VENDOR SERVICE PUBLICATION

SUBJECT: Oil Pump Impeller and Drive Replacement; AVCO Lycoming Service Bulletin No. 385C dated October 3, 1975 (attached).

Service Bulletin No. 385C
(Supersedes Service Bulletin No. 385B)
Engineering Aspects are
FAA (DEER) Approved

SUBJECT: Oil Pump Impeller and Drive Replacement

Figure 1. Interior View of Accessory Housing Showing Location of Cotter Pin in Oil Pump Idler Shaft

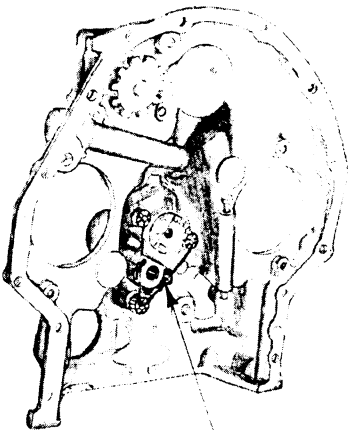
INSPECTION: Applicable remanufactured engines shipped after December 21, 1972 should be inspected to determine if this modification is required: first of all, if the engine log book indicates the engine has not been modified in accordance with Service Instruction No. 1230 or No. 1272, proceed to remove the accessory drive cover from the mounting pad at the lower right side of the accessory housing to obtain access to the area between the crankcase and the accessory housing. On some engines this accessory drive pad is not machined, in this event it will be necessary to remove either the left magneto or the *fuel pump to obtain access to the area between the crankcase and the accessory housing. Regardless of which accessory pad is used, determine if the oil pump idler gear is secured with a cotter pin at the location shown in figure 1. This can be accomplished using an inspection mirror, preferably an illuminated one. If the cotter pin is visible, it is unnecessary to perform the modification required by this bulletin.

IF IDLER SHAFT IS SECURED WITH A COTTER PIN AT THIS LOCATION MODIFICATION IS NOT REQUIRED

Figure 2. Oil Pump Drive Assembly

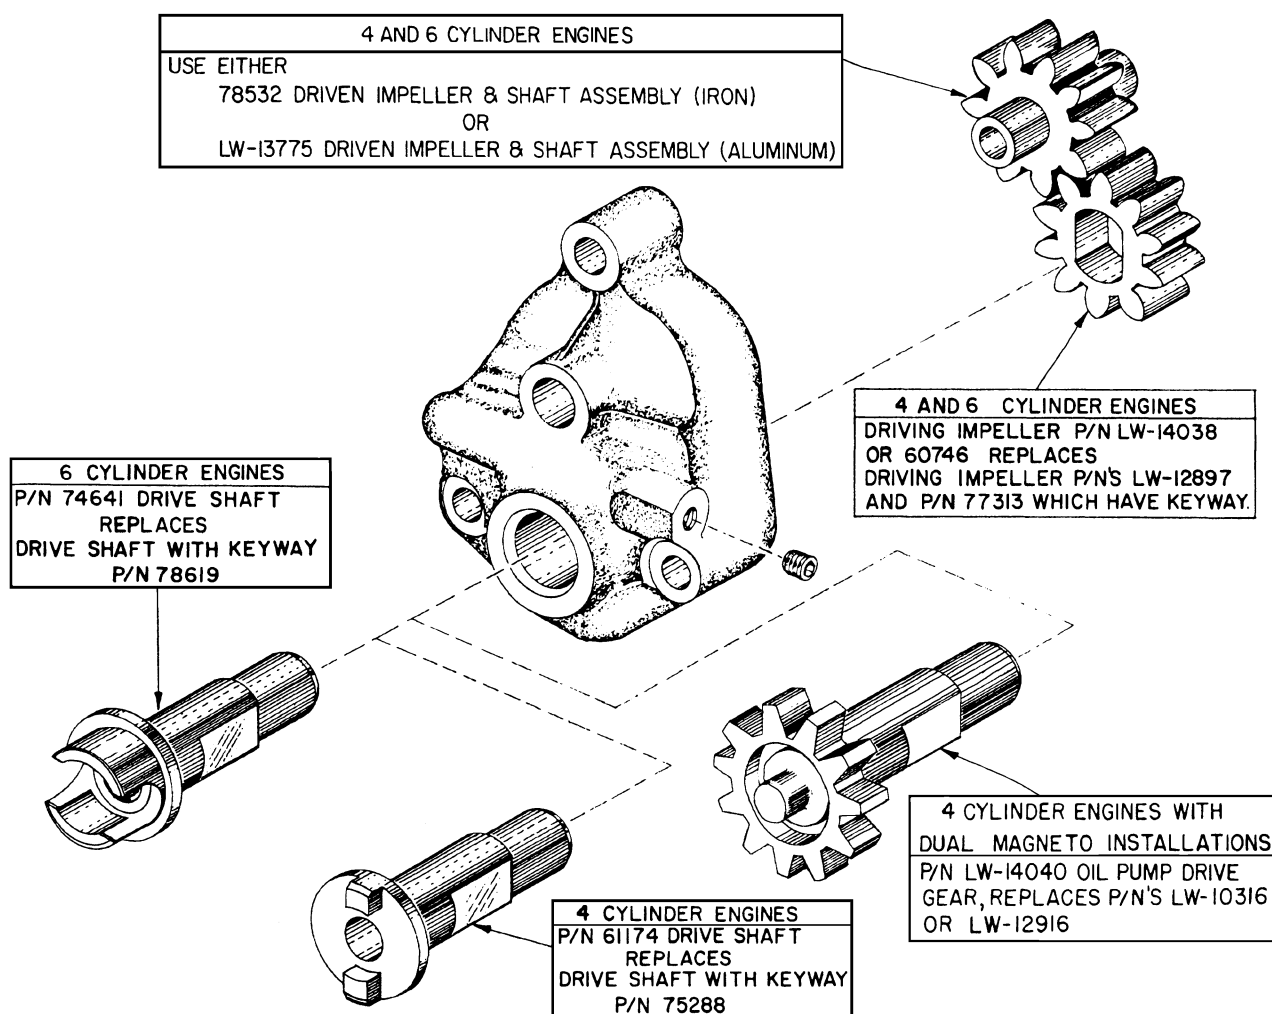
This modification consists of replacing the oil pump drive shaft and drive impeller to eliminate the Woodruff key drive which has proven to be the cause of excessive wear in the keyway of the hardened drive impeller. Therefore, it is recommended that all of the applicable engines listed in the chart, as well as any others that may have been modified in accordance with Service Instruction No. 1272, use the following procedure for parts replacement.

3. Reassemble the oil pump using the new drive shaft and drive impeller supplied with the kits shown in the following "Parts Data" section. See figure 2. Be sure all of the parts are lubricated thoroughly during assembly.

LW-14129	Gasket Kit, Oil Pump Shaft Replacement (4 cylinder engines) consists of: (1) 60096 fuel pump gasket, (3) 62224 magneto gasket, (1) 73818 accessory housing gasket, (2) LW-12681, -1200 series magneto gasket, (1) LW-13353 oil sump gasket
LW-14130	Gasket Kit, Oil Pump Shaft Replacement (6 cylinder engines) consists of: (1) 60096 fuel pump gasket, (3) 62224 magneto gasket, (1) 73818 accessory housing gasket, (2) LW-12681, -1200 series magneto gasket, (1) LW-14128 oil sump repair gasket
LW-14131	Oil Pump Shaft Replacement Kit (4 cylinder engines) consists of: (1) 61174 oil pump drive shaft, (1) LW-14038 or 60746 drive impeller
LW-14132	Oil Pump Shaft Replacement Kit (4 cylinder, dual drive magneto engines) consists of: (1) LW-14040 oil pump drive gear, (1) LW-14038 or 60746 drive impeller
LW-14133	Oil Pump Shaft Replacement Kit (6 cylinder engines) consists of: (1) 74641 oil pump drive shaft, (1) LW-14038 or 60746 drive impeller
